5.0 Reactor Coolant System and Connection Systems

5.1 Summary Description

The information in this section of the reference ABWR DCD, including all subsections and figures, is incorporated by reference with the following departures~~no departures or supplements~~.

Figure 5.1-1 Rated Operating Conditions of the ABWR

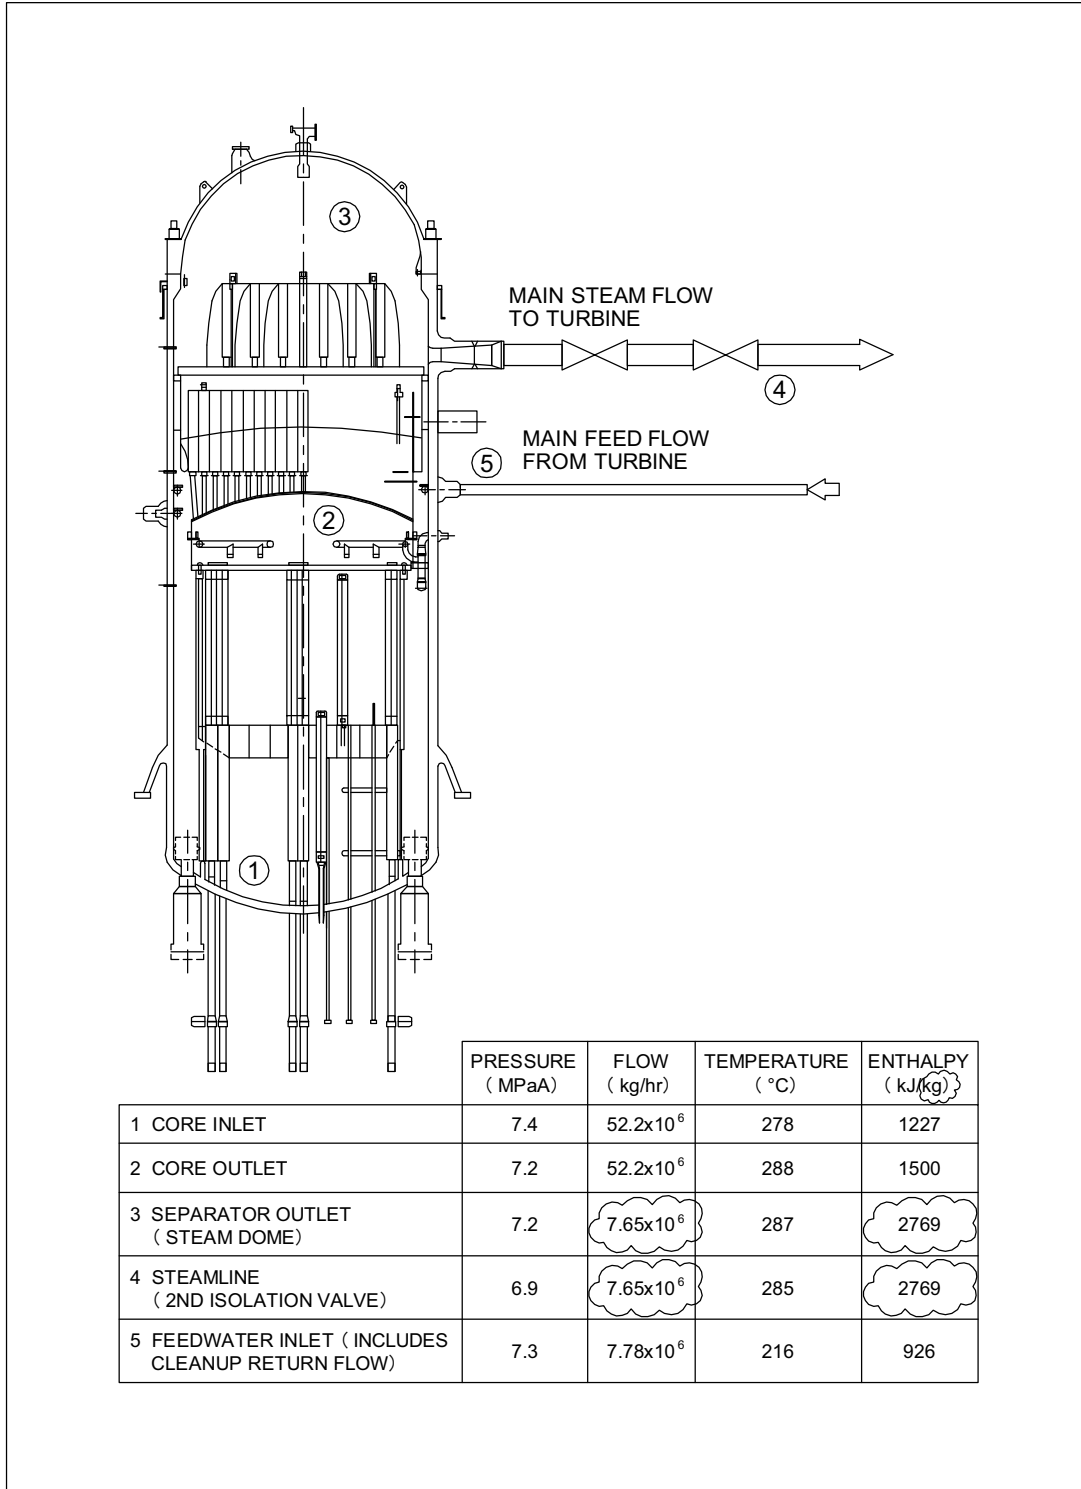
STP DEP 10.1-3 (Figure 5.1-1)
